**Sent:** 2/09/2020 4:42:11 PM  
**Subject:** FW: DA 2020/0816 23-33 BASSETT STREET MONA VALE - bur.bas37m  
**Attachments:** bur.bas37m4\_submission\_TGNNPLB\_310820.pdf;

**DEVELOPMENT APPLICATION DA 2020/0816  
23-33 BASSETT STREET MONA VALE  
PROPOSED RESIDENTIAL CARE FACILITY UNDER SEPP HOUSING  
FOR SENIORS**

This document is a submission by way of objection to Development Application 2020/0816 (the 'development application') relation to Nos 23 - 33 Bassett Street Mona Vale (the 'subject property').

**Figure 1-** North elevation showing west boundary of site and relationship with adjoining cottage style development

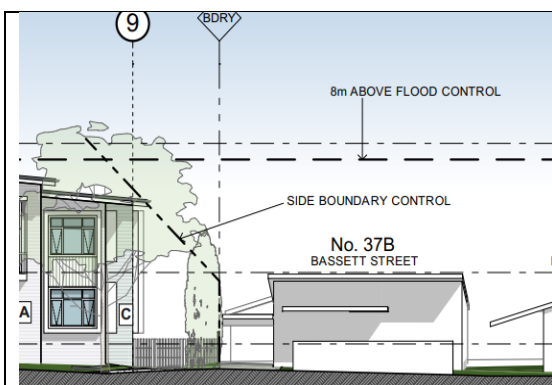
This site is not in a medium density residential zone nor is the property located in a mixed use commercial type environment. The fact that the site is zoned for 'low density residential' purposes should be instructive to the applicant as far as the development proposal is concerned. This is especially the case where low density residential extant development is to be replaced by a high density facility (over the eastern part of the land). We contend that the architect has failed to take into account the reasonable expectations of adjoining land owners and occupiers in this regard. Figures 1 and 2 below show the relationship between the proposal and adjoining development to the east and west (source Gartner Trovato Architects). In our opinion the separation between the built elements in Figure 1 is not acceptable.

In our view the building should be broken into at least two built elements crossways, so that some respect can be paid to the built form of existing cottages in other parts of this streetscape (with their narrow frontages), the relevant low density zone and the PDCP character statement suggesting that vegetation should be integrated with development. In this case the reduced street setbacks will not allow for sufficient planting to soften this bulky and very lengthy facade.

**Figure 2-** North elevation showing east boundary of site and relationship with adjoining cottage style development

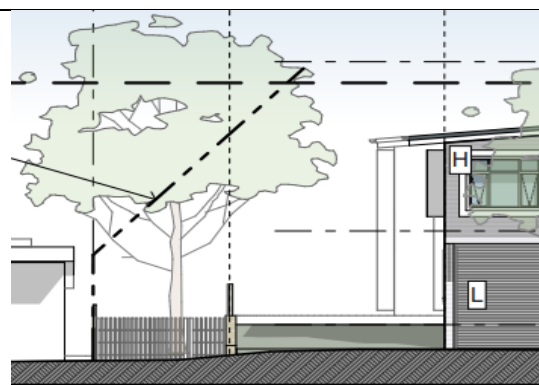
Below is an extract from the drawings by Gartner Trovato Architects, showing the length of proposed building (around 95m total), when viewed from Bassett Street. The long, unarticulated length of this facade, is completely uncharacteristic of adjoining and nearby development. As Council will be aware the existing building is at odds with the nearby building character. When this bulk is extended for a further distance along Bassett Street, a significant change in the dominant character of the southern side of Bassett Street will result. In our minds this is particularly undesirable.
